**TOWN OF BROOKFIELD
PLAN COMMISSION MINUTES
May 23, 2023**

TOWN OF BROOKFIELD PLAN COMMISSION ZONING REPORT

RE: **Quest Interiors – Final Approval**
21055 Crossroads Circle BKFT1129999007

Strand Associates, Inc.® (Strand) has finished its review of the construction drawings and Storm Water & Erosion Control Calculations resubmittal for the Quest Interiors Development that were received from Excel Engineering, Inc. (Excel) on May 22, 2023, for conformance with the Town specifications and general engineering practices. Before construction may begin, the contractor shall submit all required permits for the development to the state, Wisconsin Department of Natural Resources, Town, and any other relevant agencies. New drawings, stormwater management plan and calculations, and a letter describing the revisions should be returned to Strand after the following concerns have been addressed. Excel's responses to Strand's original comments are *italicized* and Strand's most recent comments are in **bold**.

Civil Utility Plan—Sheet C1.3

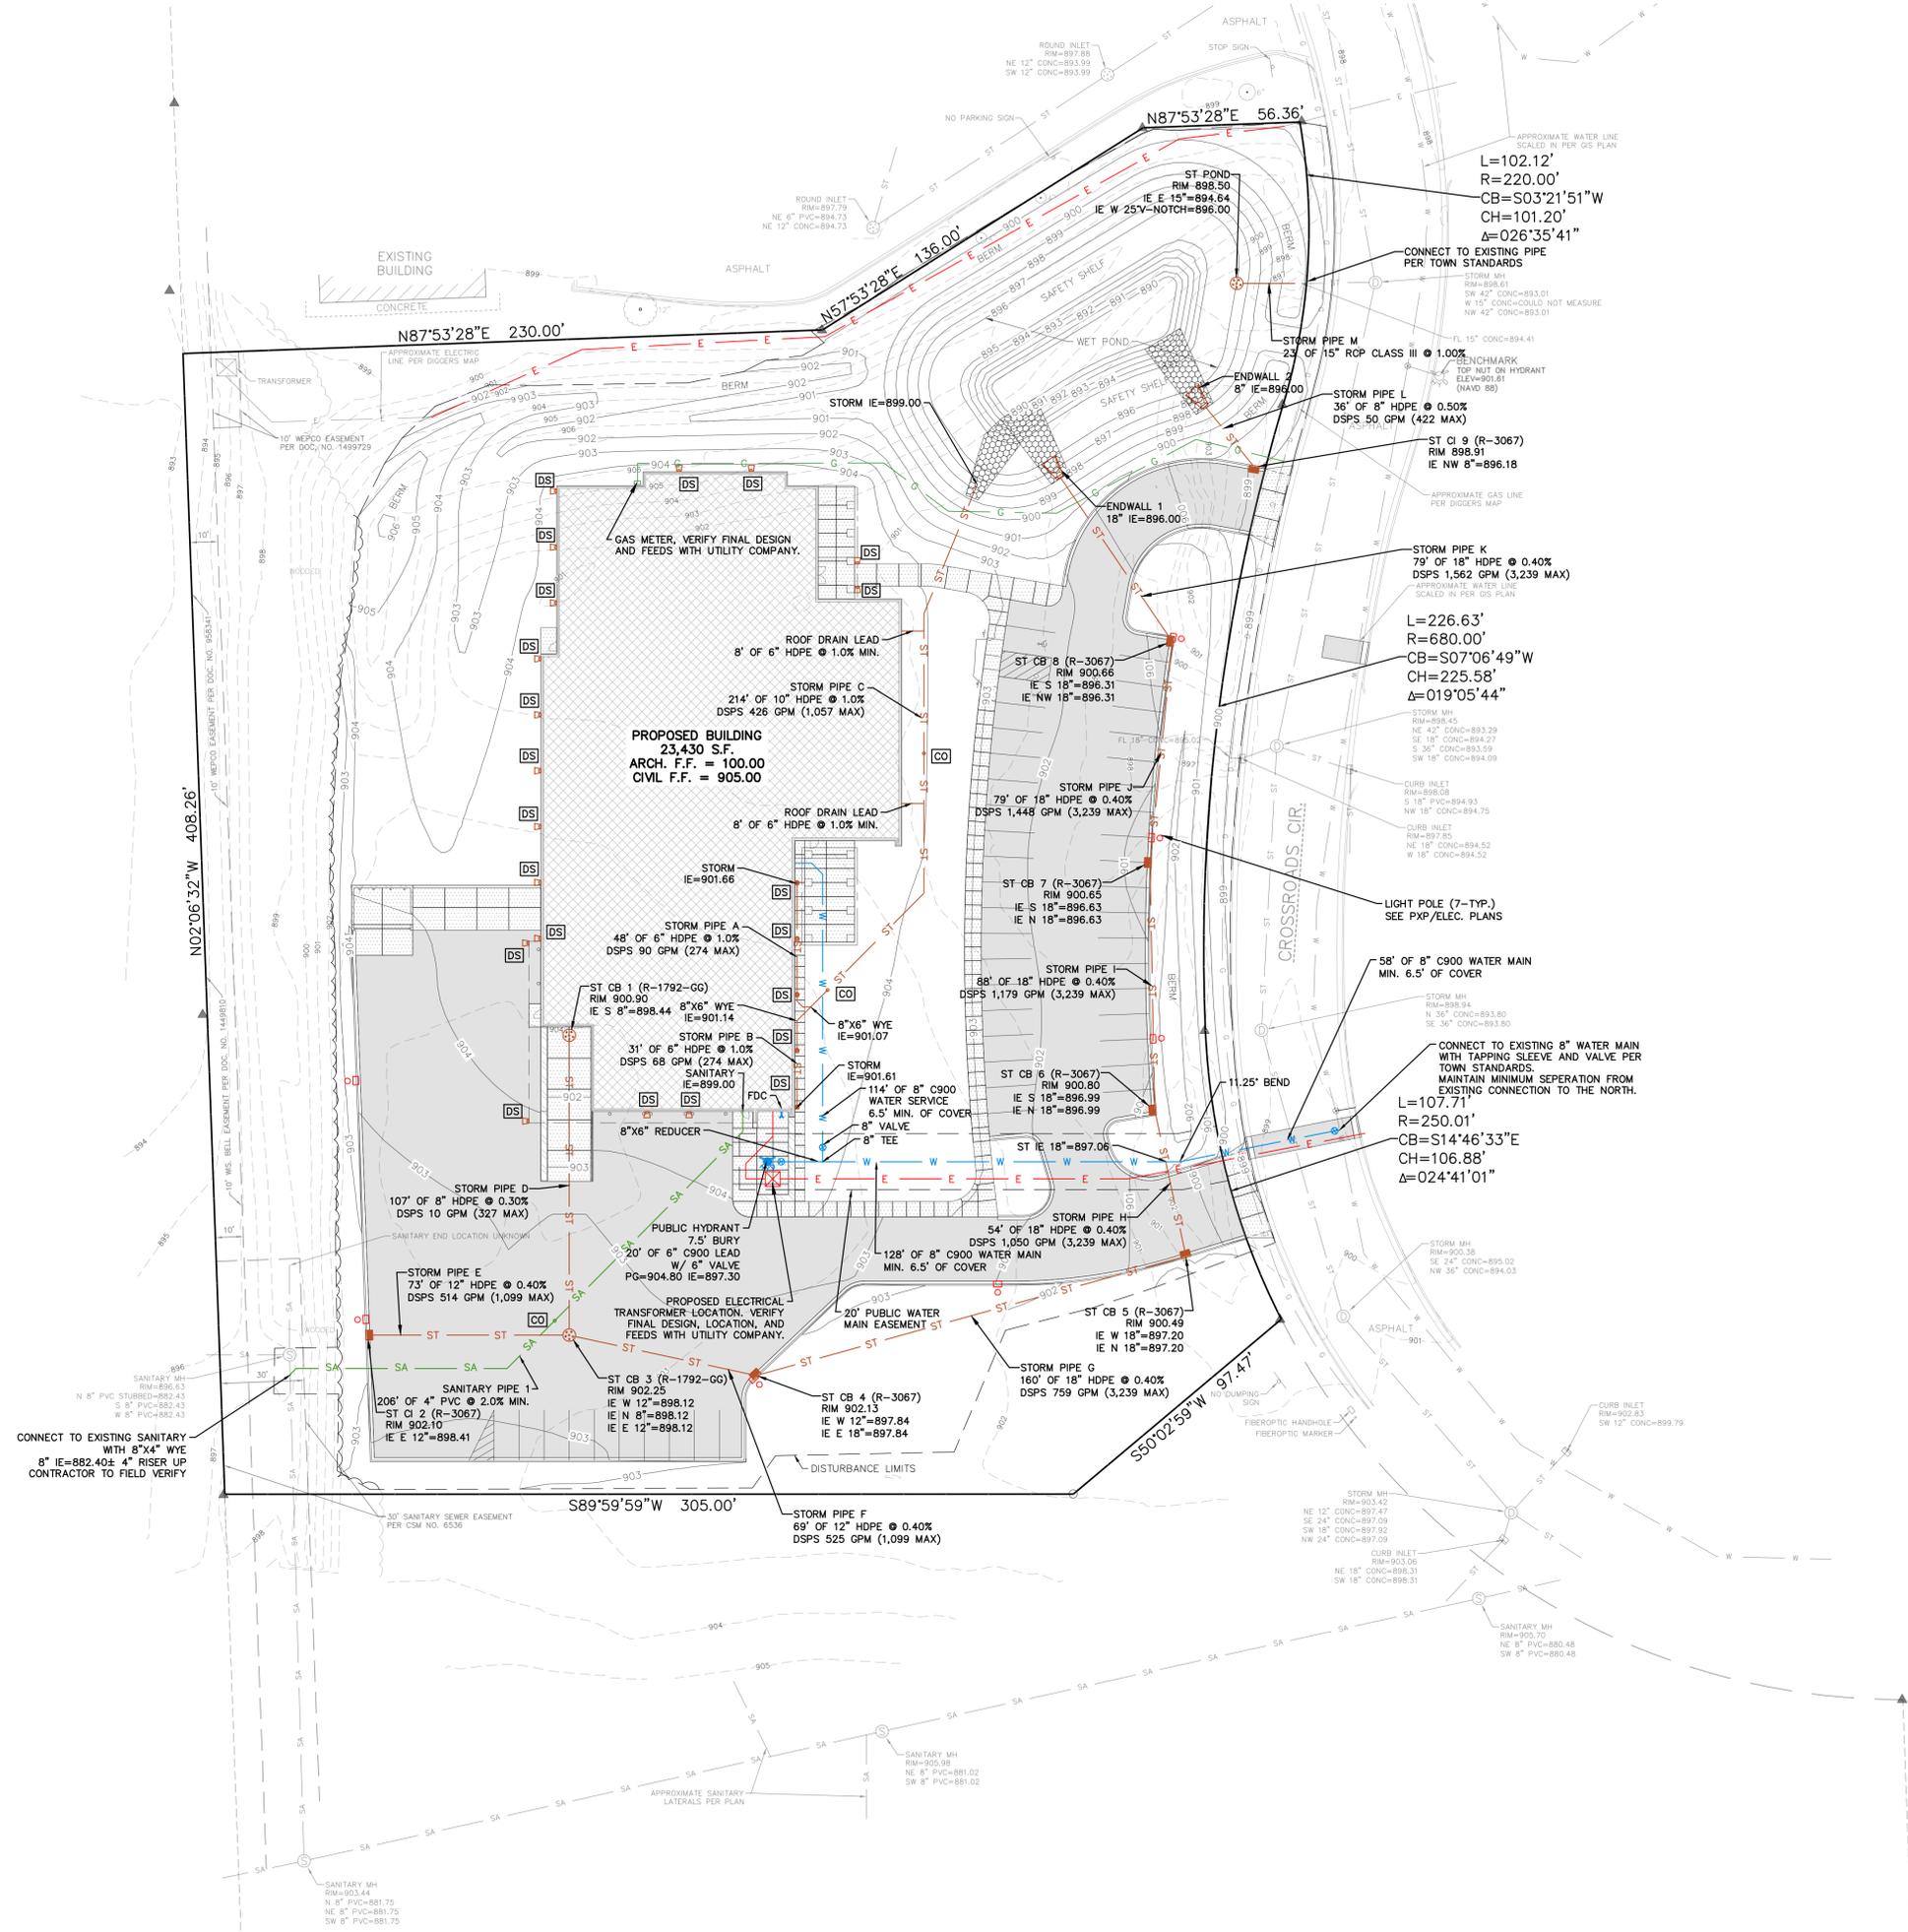
1. Strand's May 3, 2023, Comment—The callout for the rim elevation of CB-1 (901.12) does not match the callout for the rim elevation shown in the Bay Loading Dock Detail (900.90).

2. Strand's May 3, 2023, Comment—Evaluate that proper separation between water, storm, and sanitary sewer mains are meeting the requirements of Section NR 811.74 of the Wisconsin Administrative Code (WAC).

3. Strand's May 3, 2023, Comment—The storm sewer structure and casting types should be called out on the plan.

4. Strand's May 3, 2023, Comment—Review that all water main design meets the requirements of Section NR 811.70 of WAC and Section 12 of the Town Sanitary District No. 4 technical specifications (see Sections 12.1—Water Main Material, 12.2—Valve Type, 12.3—Pipe Cover and length requirements, 12.5—Thrust Restraint, and 12.18—Fire Hydrant Type). Supporting documentation should be provided.

5. Strand's May 3, 2023, Comment—It should be noted that, before water utility construction can begin, a modification to the water service application will need to be submitted to the Town and, if plumbing fixtures are being added, calculations should be provided for proper meter sizing.

6. Strand's May 3, 2023, Comment—A note should be added stating that the contractor shall notify the Town Sanitary District No. 4 and field staff a minimum of 72 hours before the start of any construction or connection to existing public utilities.

7. Strand's May 3, 2023, Comment—The existing sanitary sewer is not shown correctly on the west side of the property where the proposed sanitary service connection to the main is taking place. The sewer main is entering the manhole from the west and then heads south. There is no sewer line running north of this manhole (see enclosed markup). This will require a modification of the proposed sewer service connection to the main.

8. Strand's May 3, 2023, Comment—A 6-inch water valve should be added to the proposed water service (see enclosed markup).

9. Strand's May 3, 2023, Comment—The proposed water main tapping location is near an existing water service connection. A note should be added stating the required distance from the existing connection.

10. Strand's May 3, 2023, Comment—The scale bar appears to be incorrect.

Excel's May 22, 2023, Response—The rim elevation on C1.3 for ST CB 1 has been revised to match the detail.

Strand's Current Response—It was confirmed that elevations now match on both sheets.

Excel's May 22, 2023, Response—A minimum separations are maintained throughout the design.

Strand's Current Response—It appears the proper separation distance between water and storm crossings are maintained.

Excel's May 22, 2023, Response—Abbreviation designations are on the plan sheet to correspond to detail on C2.1.

Strand's Current Response—It was verified casting types are called out for each structure.

Excel Response: Design requirements are met and notes and details have been added to the plans.

Strand's Current Response—It was verified notes and details were added to the construction drawings.

Excel's May 22, 2023, Response—This note has been included on plan sheet C1.3.

Strand's Current Response—It was verified that the note was added to Sheet C1.3.

Excel's May 22, 2023, Response—This note has been included on plan sheet C1.3.

Strand's Current Response—It was verified that the note was added to Sheet C1.3.

Excel's May 22, 2023, Response—The sanitary lateral location has been modified based on this information.

Strand's Current Response—The existing sanitary sewer line north of the manhole is still shown. This does not exist and should be removed. It should be verified that the proposed 4-inch-diameter lateral has adequate capacity to handle proposed loadings.

Excel's May 22, 2023, Response—The water service location has been revised and a valve has been added to plans.

Strand's Current Response—It appears that the fire hydrant and valve will be located behind a masonry wall and near an electrical transformer. It should be verified there is enough room for access by the fire department and Town Sanitary District No. 4 for emergency situations and maintenance.

Excel's May 22, 2023, Response—The connection note on plan sheet C1.3 has been revised to reflect this.

Strand's Current Response—It was verified that a note was added regarding maintaining the minimum separation distance from the existing connection.

Excel's May 22, 2023, Response—This has been rectified.

Strand's Current Response—Confirmed.

CIVIL LANDSCAPE AND RESTORATION PLAN

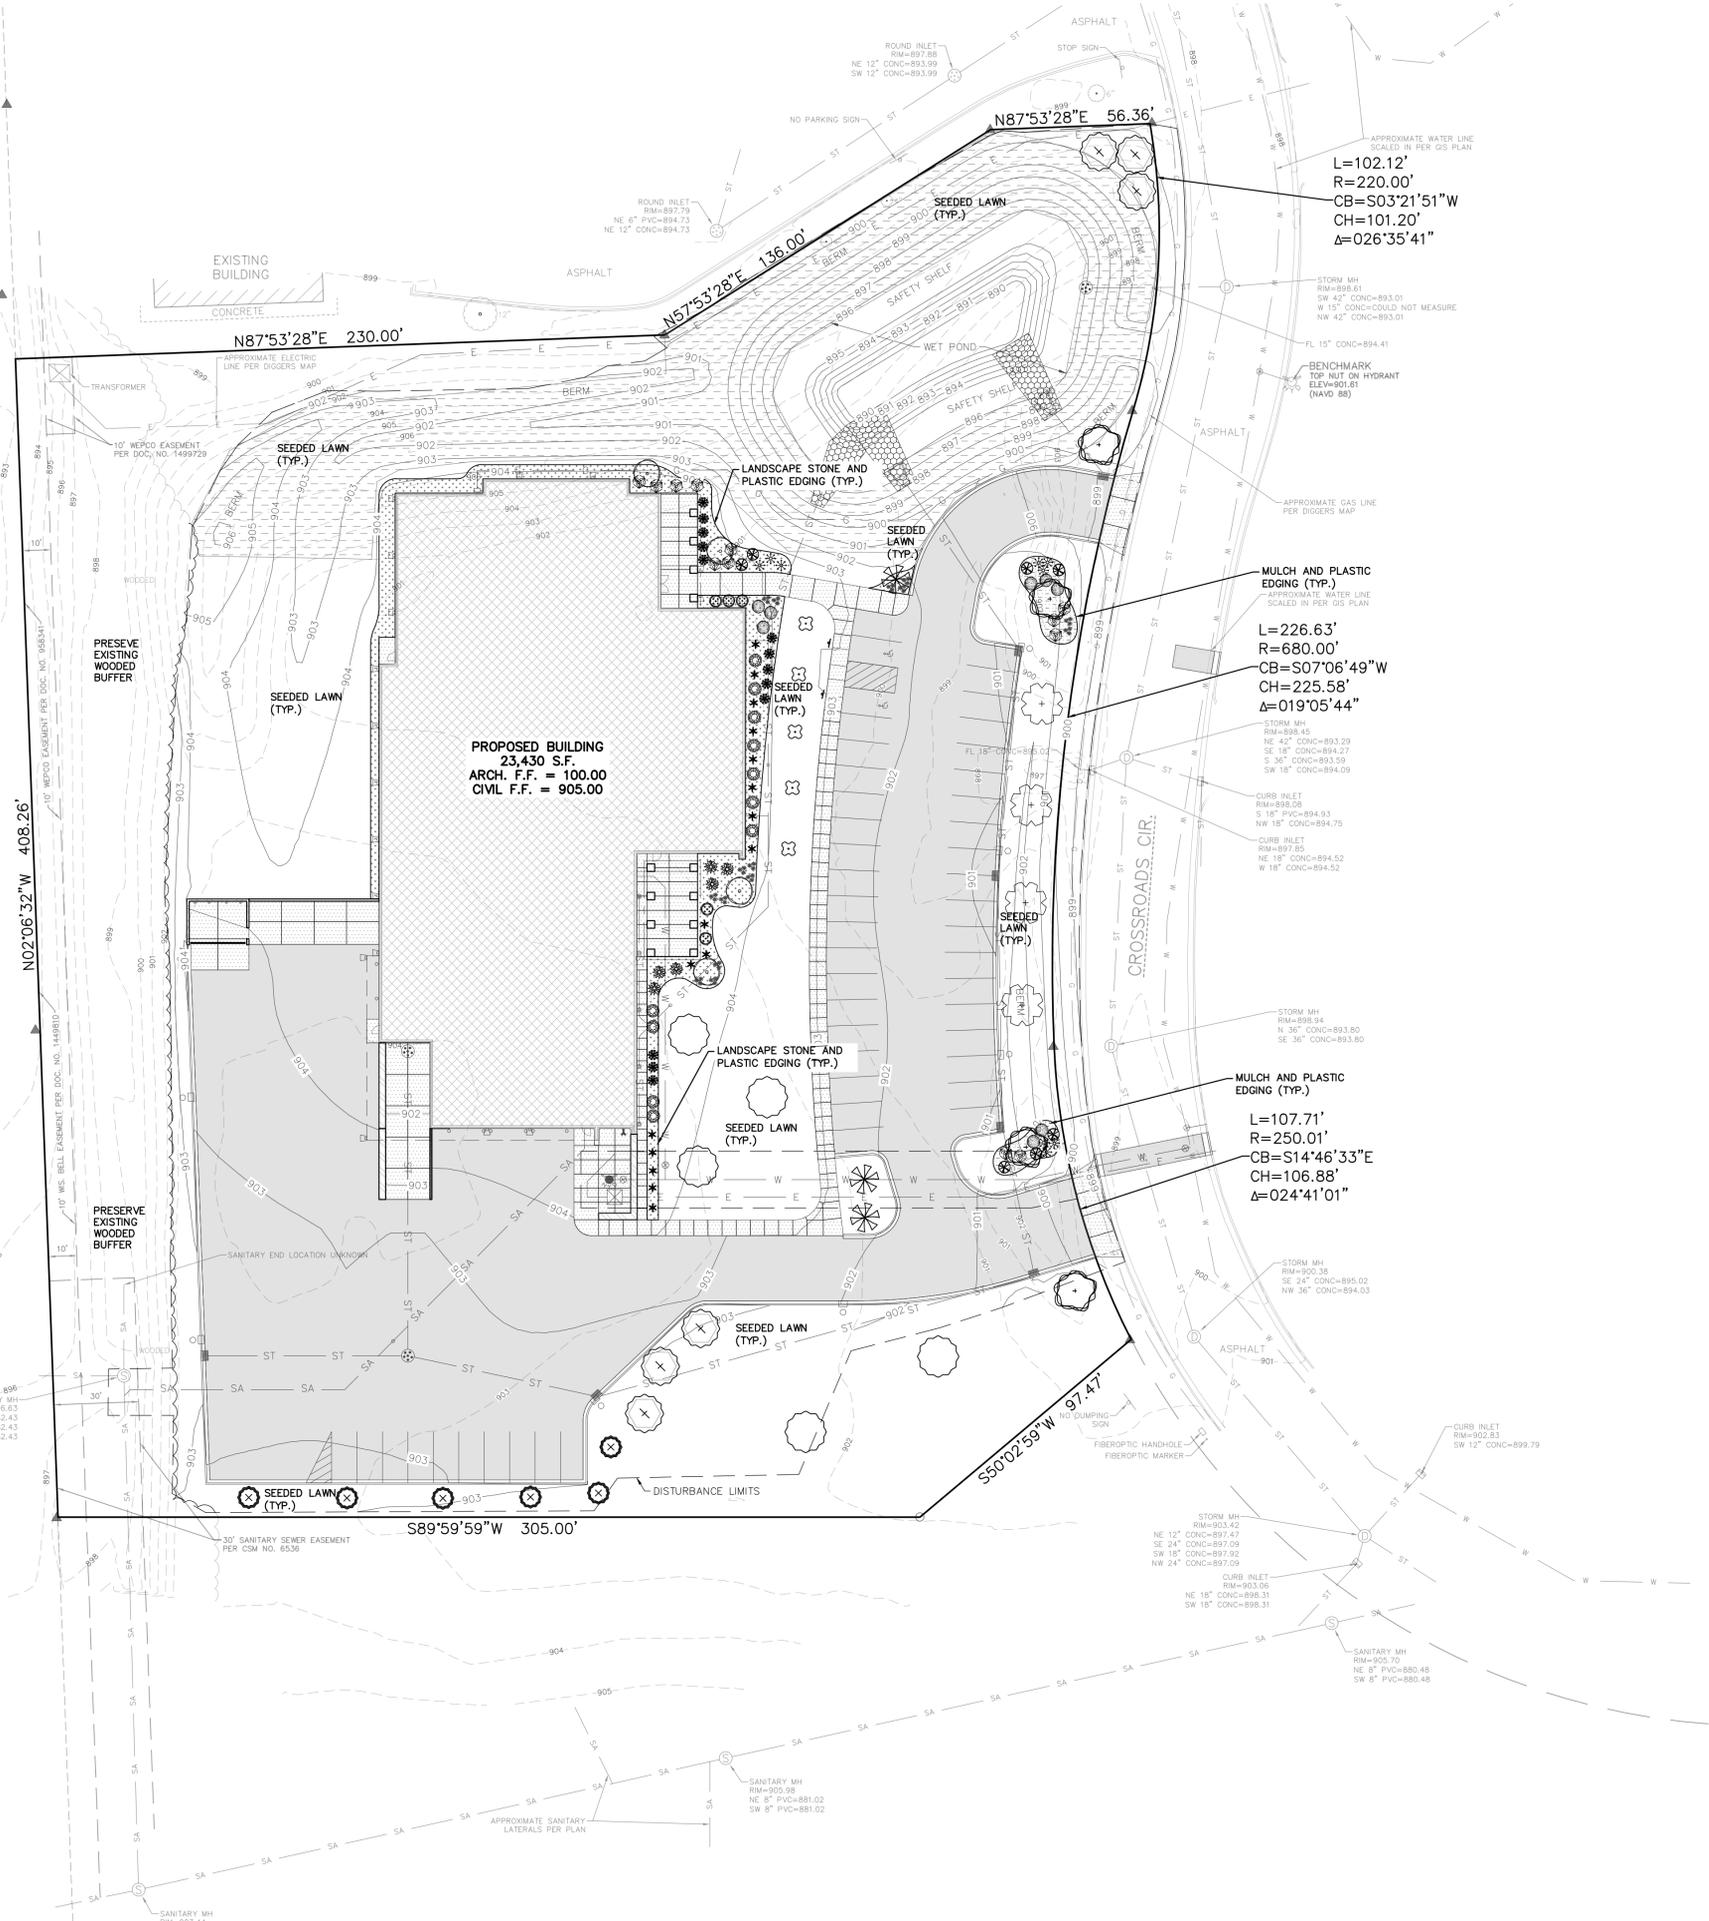
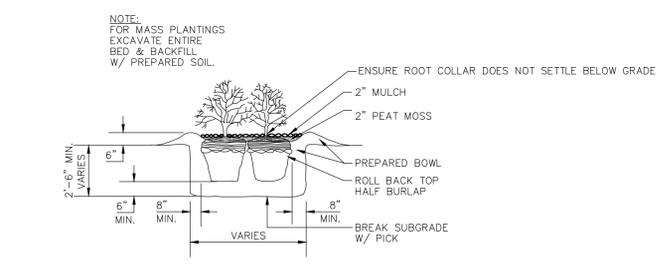
1. Strand's May 3, 2023, Comment—Please denote intended tree protection or woodland area protection provided on-site.

- a. Strand's May 3, 2023, Comment—According to plant symbols and the plant data chart, selected species appear appropriate. A full comparison of plan quantities as laid-out versus in the planting table was not completed. It may be appropriate for plant callout leaders for use in the field or for final reviews. Planting densities, arrangement, and selection appear appropriate. See notes.

- b. Strand's May 3, 2023, Comment—Varieties of flowering pear (*Pyrus calleryana*) are regarded as potentially invasive. If acceptable, please explore potential replacements such as suitable varieties of flowering crabapple (*Malus* species) or redbud (*Cercis canadensis*).

- c. Strand's May 3, 2023, Comment—Deciduous shrub “Planted Size” below 18 inches does not meet code. Please remove 15-inch reference for deciduous shrubs.

- d. Strand's May 3, 2023, Comment—Similarly, arborvitae “Planted Size” should be corrected to the 6-foot requirement, in accordance with code.

- e. Strand's May 3, 2023, Comment—Please revise Botanical Name (genus) for Karl Forester Reed Grass as “Calamagrostis.”

3. Strand's May 3, 2023, Comment—Long-term light pole interference—The seeded lawn area between the parking lot and Crossroads Circle (and some other project areas) contain light poles with large deciduous tree plantings (basswood and honeylocust) within 10 to 12 feet of the poles. Please evaluate spacing arrangements or evaluate the use of smaller trees as needed.

4. Strand's May 3, 2023, Comment—Because of proximities within 12 feet of the Crossroads Circle road surface, please review planting beds that are present north and south of site access drives to confirm that they are appropriately resistant or distant to potential salt spray and other effects of the roadway and associated ditch.

5. Strand's May 3, 2023, Comment—To potentially avoid installation “settling” of plantings, burial of root collars, and potential survivability issues; please consider additions to the Tree Planting and Shrub Planting Details. This may involve altering the figure or potentially calling out plants to be “set” in the planting hole on a rigid substrate and similarly denoting the location of the root collar relative to planting and mulch placement.

6. Strand's May 3, 2023, Comment—The scale bar appears to be incorrect.

Excel's May 22, 2023, Response—Plan notes are on C1.0 and C1.4 to provide intent of preservation of wooded area.

Strand's Current Response—Notes were reviewed and are adequate.

Excel's May 22, 2023, Response—The Jack pear species has been substituted with a flowering crabapple.

Strand's Current Response—The replacement species appears to be adequate.

Excel's May 22, 2023, Response—Planting size of shrubs have been revised to a minimum of 18-inches.

Strand's Current Response—It was confirmed that the planting size of shrubs was revised to a minimum of 18 inches.

Excel's May 22, 2023, Response—The planted size of Arborvitae species has been modified to 6-feet.

Strand's Current Response—It was confirmed that the planted size of Arborvitae species has been modified to 6 feet.

Excel's May 22, 2023, Response—The Botanical name is shown as Calamagrostis.

Strand's Current Response—It was confirmed that the botanical name spelling is now correct.

Excel's May 22, 2023, Response—Adjustments have been made to the tree count and location to address spacing.

Strand's Current Response—The tree count and revised tree locations appear to be adequate.

Excel's May 22, 2023, Response—Based on the separation of both distance and elevation from the roadway the plantings should be protected from deterioration.

Strand's Current Response—Confirmed and understood.

Excel's May 22, 2023, Response—Adjustment to details and additional notes are included to addresses settling.

Strand's Current Response—The root collar note is acknowledged and suitable. It is suggested that both the tree and shrub planting detail denote an undisturbed planting mound directly under the plant and a callout leader added such as “ Retain a portion of undisturbed subgrade to support plant weight and avoid plant settling.”

Excel's May 22, 2023, Response—This has been rectified.

Strand's Current Response—Confirmed.
